To: T10 SAS Protocol Working Group

Subject: SAS 2 : 08-216 Retry to Open Limit timer fix

Overview

Figure 118 — Port layer examples

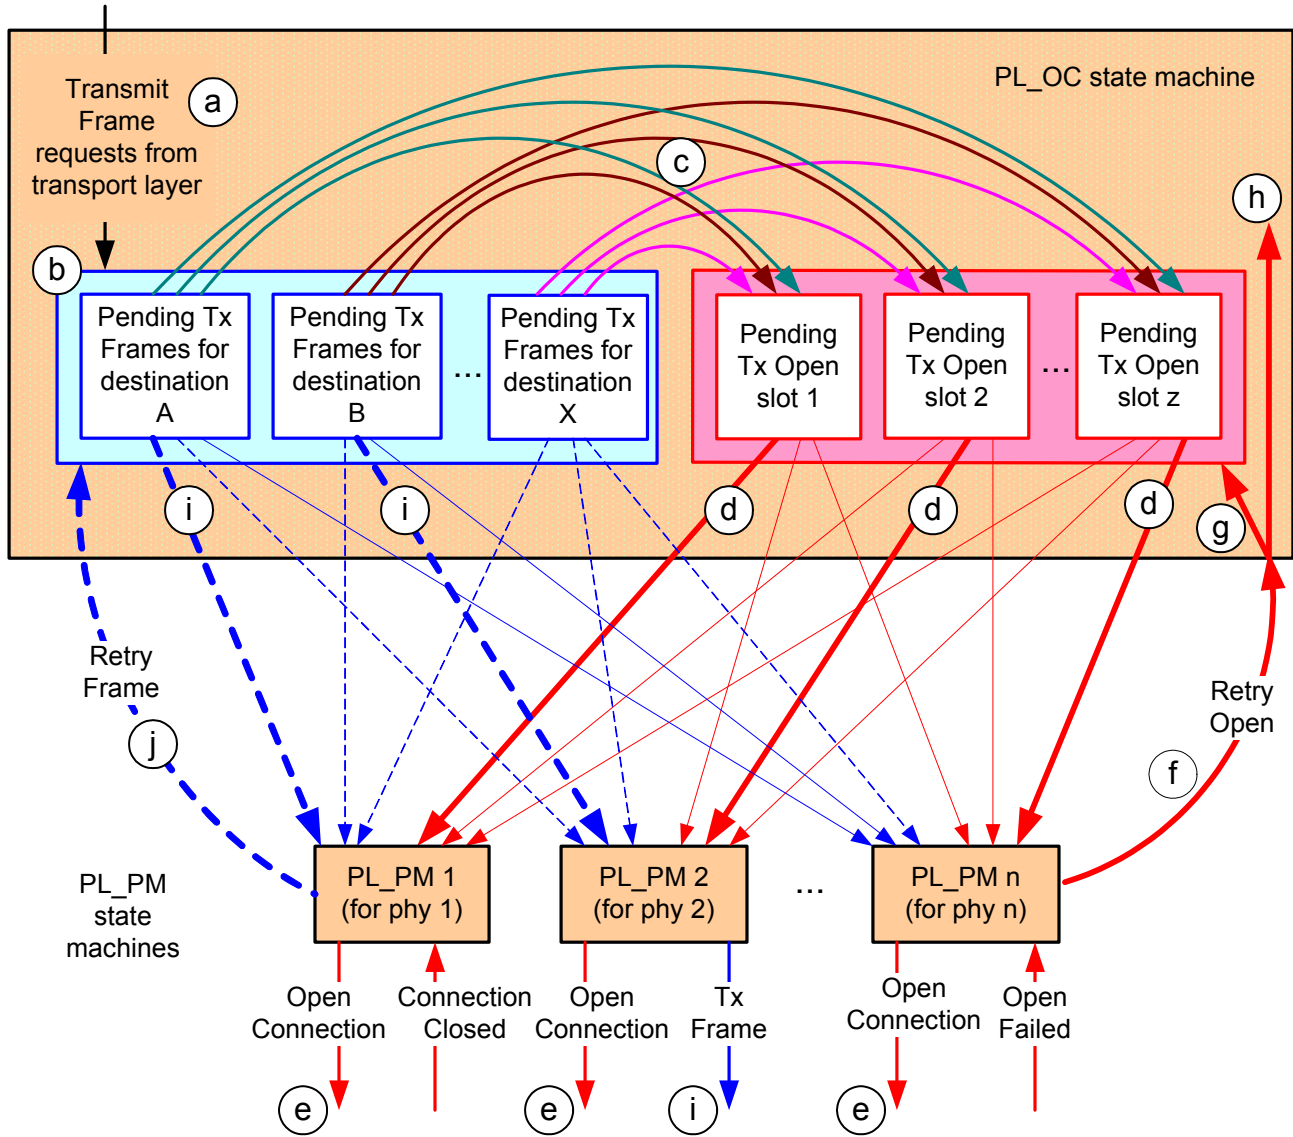
Editor's Note 1: Note in above figure, the Pending Tx Open slot index was changed from "n" to "z". I was not able to quickly figure out how to add the change bar notation or character formatting.

- a) Transmit Frame requests are received by the PL_OC state machine;
- b) the PL_OC state machine converts Transmit Frame requests into pending Tx Frame messages associated with the destination SAS address;
- c) the PL_OC state machine generates a pending Tx Open message for a pending Tx Frame message when there is a pending Tx Open slot available (i.e., the number of pending Tx Open messages is less than or equal to the number of phys-destination addresses);

- g) ~~after the Reject To Open Limit timer, if any, has expired, and~~ if there is a pending Tx Open slot available, then the PL_OC state machine converts a Retry Open message to a pending Tx Open message with the pathway blocked count and arbitration wait time context from the Retry Open message applied to the pending Tx Open message, and may start the Reject to Open Limit timer;
